Specifications for Electrical Installations and Supplements

Errata and Revisions

JANUARY 2020

for the Electric System Bulletin 750 Series

FIGURE 11: TYPICAL MANHOLE REQUIREMENTS

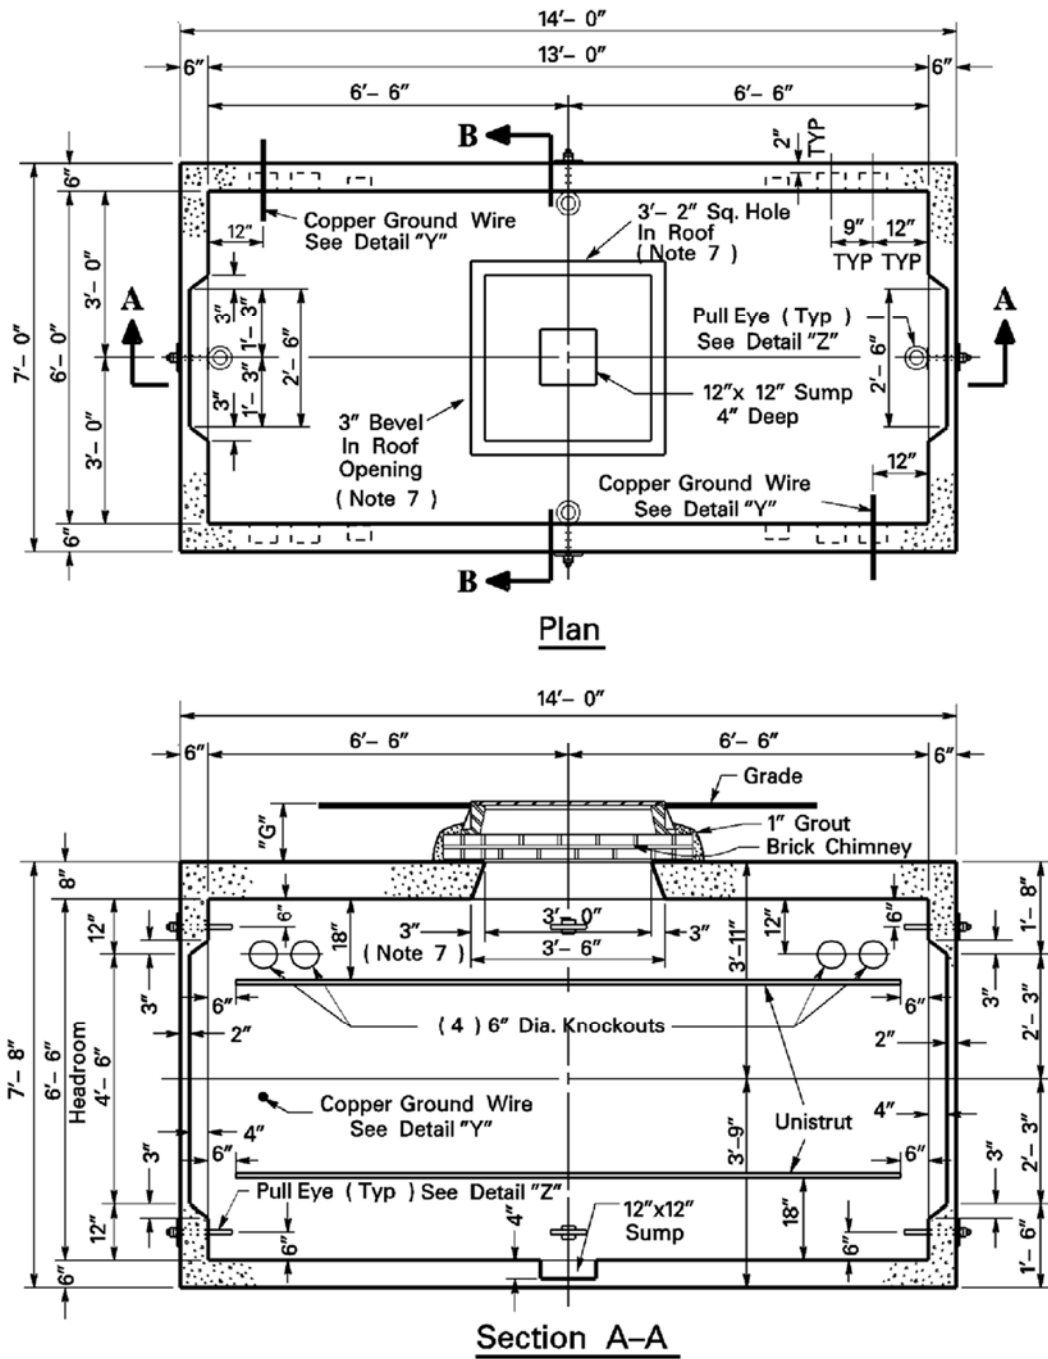
31	Figure 11	Sep-2010	Replace typical manhole requirements drawing with updated ground wire; see * below.
32	Figure 11 (cont’d)	Sep-2010	Replace typical manhole requirements continuation drawing with updated proper ground wire and detail Y; see * below.

Figure M-1 – Typical Primary Switchgear Metering Transformer Compartment Clearances

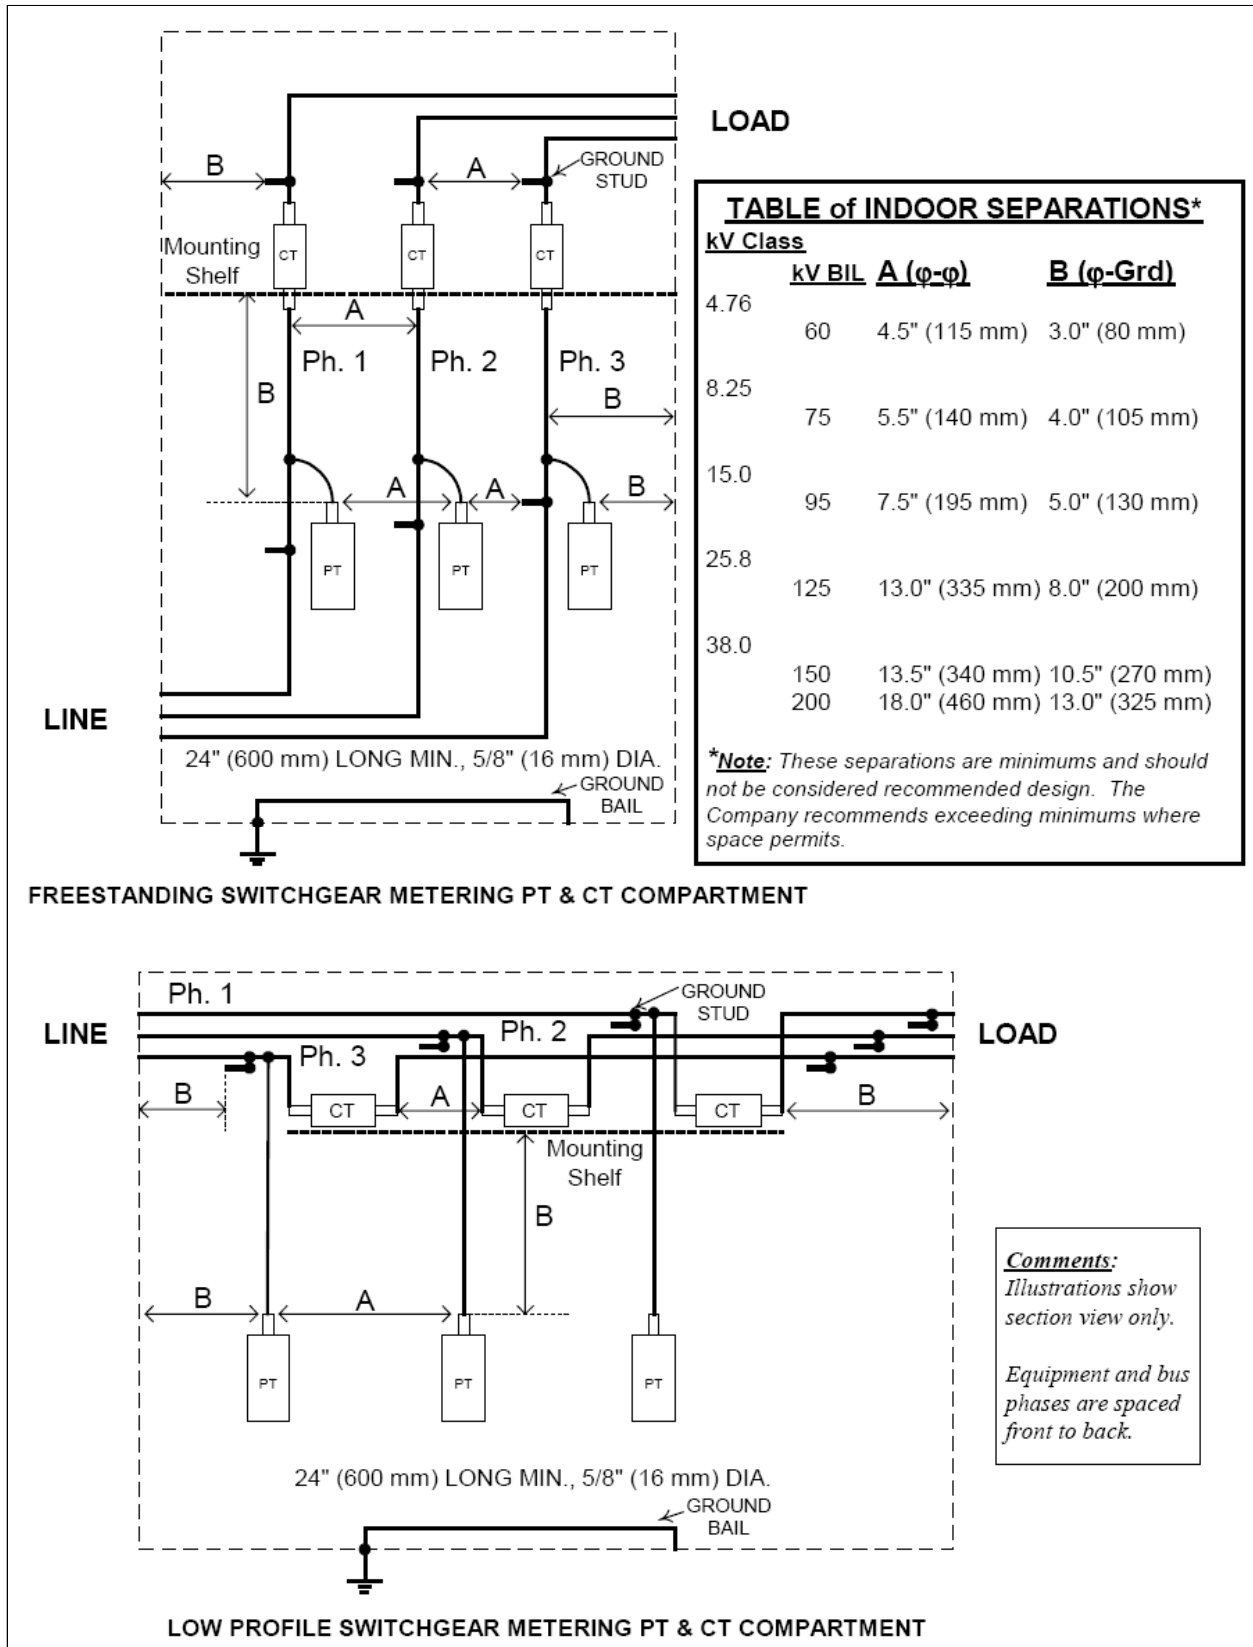
PAGE	SECTION	EFFECTIVE DATE	CHANGE
2	C Paragraph 11	Nov-1999	Delete the Inspection part in its entirety.
3	H	Nov-1999	Delete Paragraphs 18 through 20 and Paragraph 22.
4 and 5	I	Nov-1999	Delete Paragraphs 23 through 26.
5	J Paragraph 28	Nov-1999	In the first sentence, change “outdoor” to “indoor”.
8 - 10	M	Sep-2010	Change this metering section in its entirety and replace it with the new information ** below.
Fig. 1	Note #3	Apr-2002	In Note 3, change “see Paragraph 18” to “see ESB 750 Section 4”.

- d. The entire metering compartment shall be designed and constructed with adequate ventilation.
- e. The minimum width of the metering transformer compartment must be based on the electrical clearances of Figure M-1. The Customer shall maintain a minimum 10 ft. (3.0 m) unobstructed clearance in front of the metering transformer compartment access door.

- k. The metering transformer compartment shall be solely accessible by the Company. This requires section-to-section openings for through bus to be maintained as small as phase to ground clearances in Figure M-1 will allow.

- l. Where the clearances in Figure M-1 cannot be provided, Glastic (NEMA Type GPO 3 material) barriers are required between potential transformers and between potential transformers and the enclosure walls.

Figure 1A – Clear Area Requirements in Front of Line Termination and Metering Transformer Compartments for 15kV Class Primary Switchgear

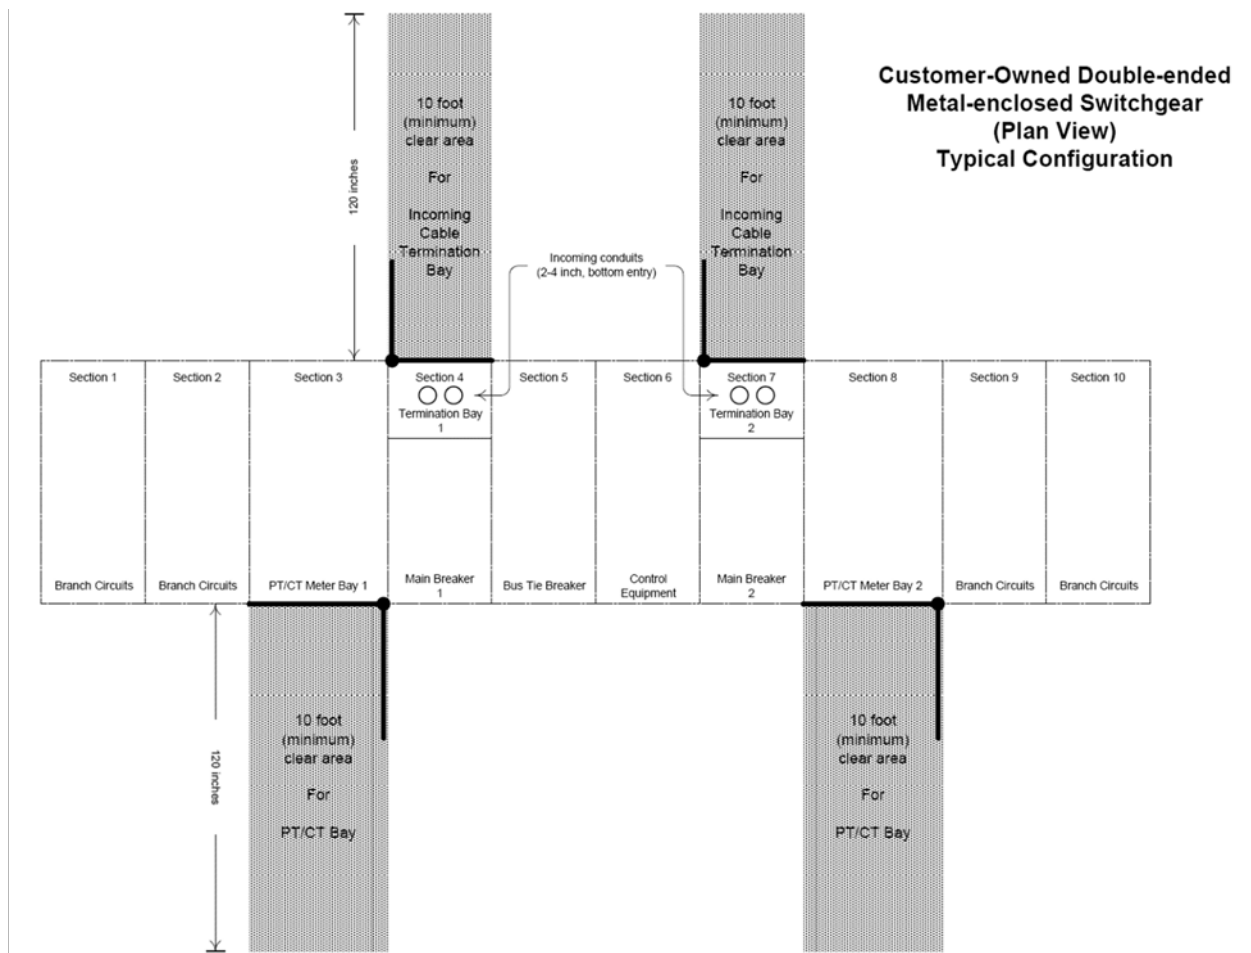
PAGE	SECTION	EFFECTIVE DATE	CHANGE
Fig. 1	Note #4 (new)	Sep-2010	Add new note: "Note #4: The clearances shown from the front of the service equipment to a building wall and from the rear of the service equipment to a building wall shall be both 10 foot (minimum) if the switchgear is designed with the Company required access to the incoming termination compartment on one side while the metering PT/CT compartment is on the other side; see Figure 1A. Otherwise, if the Company's access to both compartments is on the same side, then the other side's clearance can be reduced to the clearances presently shown." Add new Figure 1A ** below.
